**Whitehorse Planning Scheme Amendment C220whse  
Residential Corridors Built Form Study**

**Correction to the Panel Report**

**20 July 2023**

**Table 1 to Schedule 11**

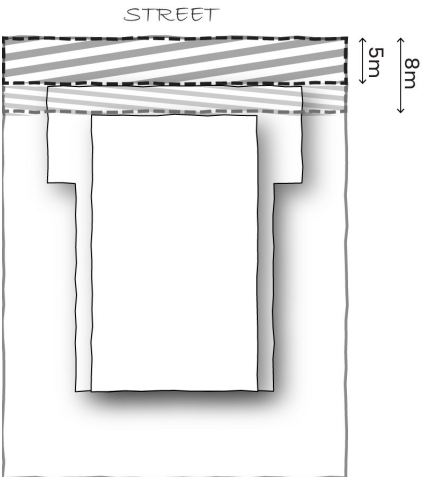
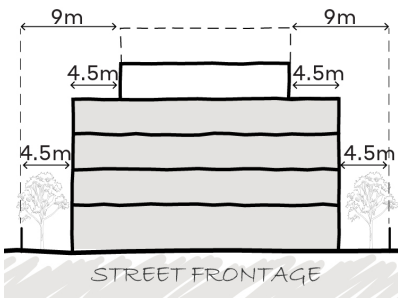
*[Panel note: revise the diagrams in Tables 1 and 2 to remove the 'T' shape, and clarify the setback interface as described in the measure]*
